ACCESS REPORT

PROJECT: The Maltings (Building M3 + M4)
PROJECT NO: GDL230009 (previous GDL200097)
PREPARED FOR: Halcyon Hotels Pty. Ltd.
REVISION: 04
DATE: 28/02/2024

M3/4 Site/Structure Plan

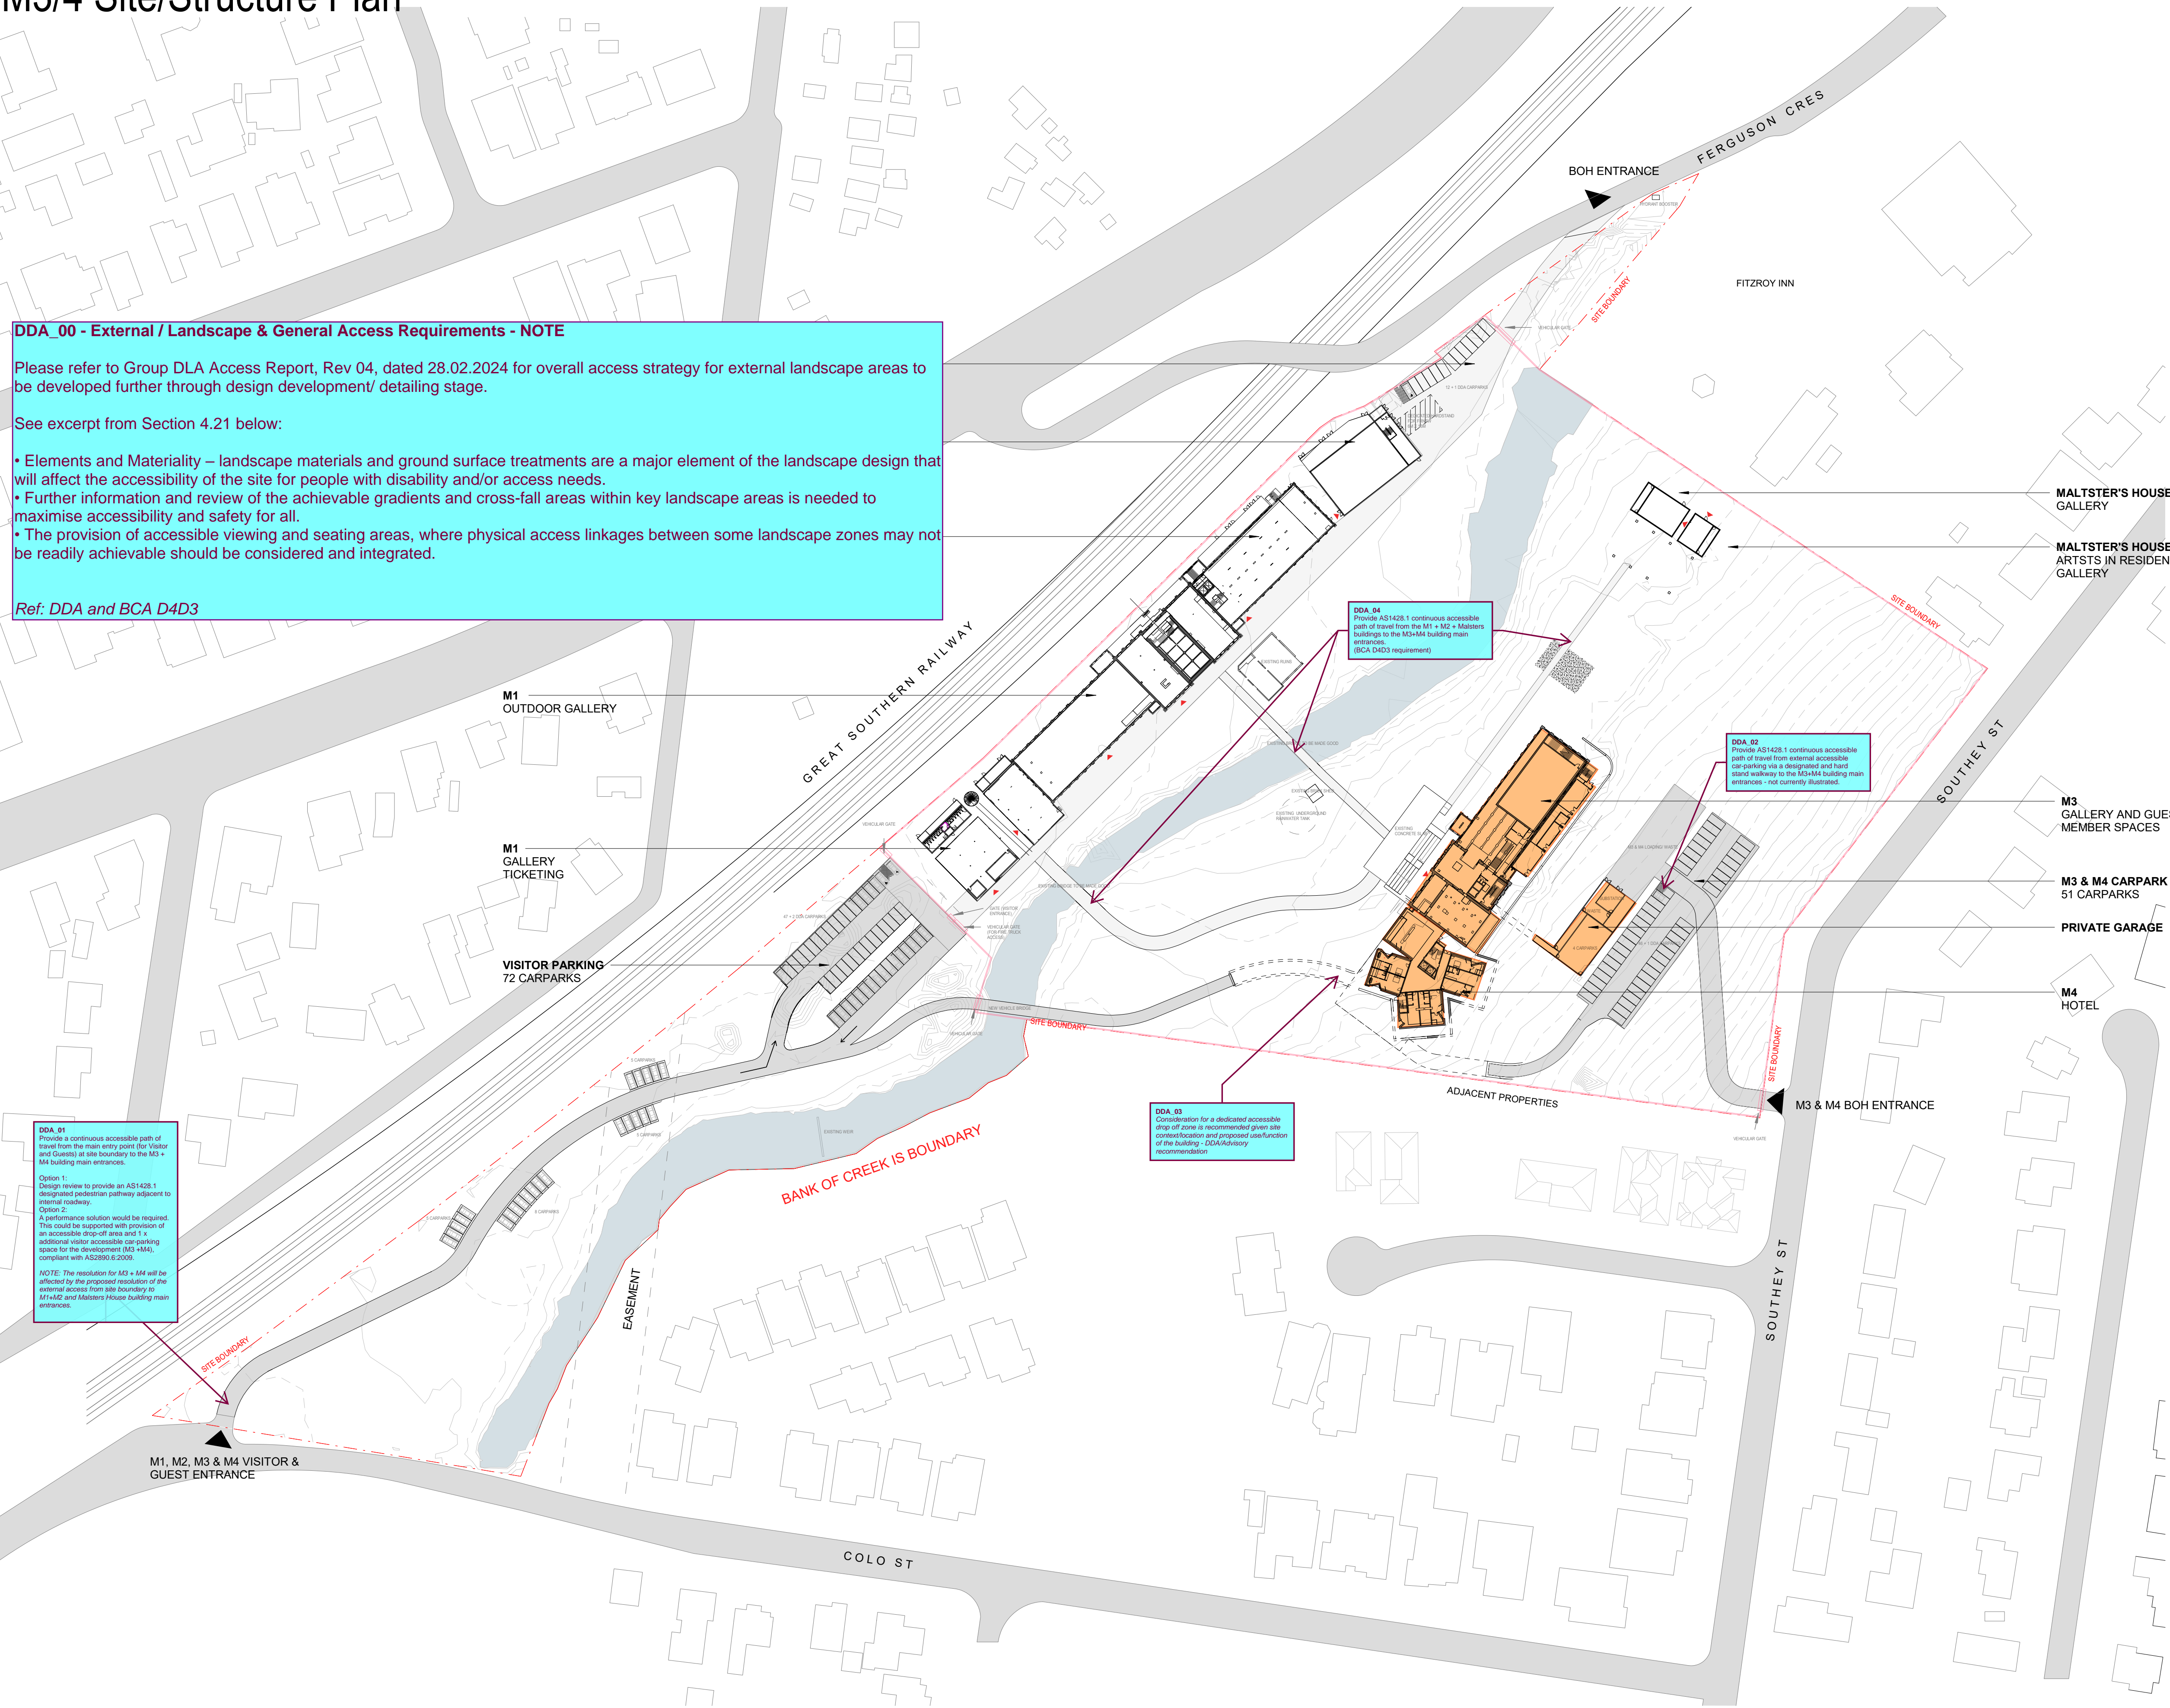
DDA_01
Provide a continuous accessible path of travel from the main entry point (for Visitor and Guest) at site boundary to the M3 + M4 building main entrances.

Option 1:
Design review to provide an AS1428.1 designated pedestrian pathway adjacent to internal roadway.

DDA_03
Consideration for a dedicated accessible drop off zone is recommended given site context/location and proposed use/function of the building - DDA/Advisory recommendation

DDA_04
Provide AS1428.1 continuous accessible path of travel from the M1 + M2 + Malters buildings to the M3+M4 building main entrances - (BCA D4D3 requirement)

DDA_02
Provide AS1428.1 continuous accessible path of travel from external accessible car parking via a designated and hard stand walkway to the M3+M4 building main entrances - not currently illustrated.
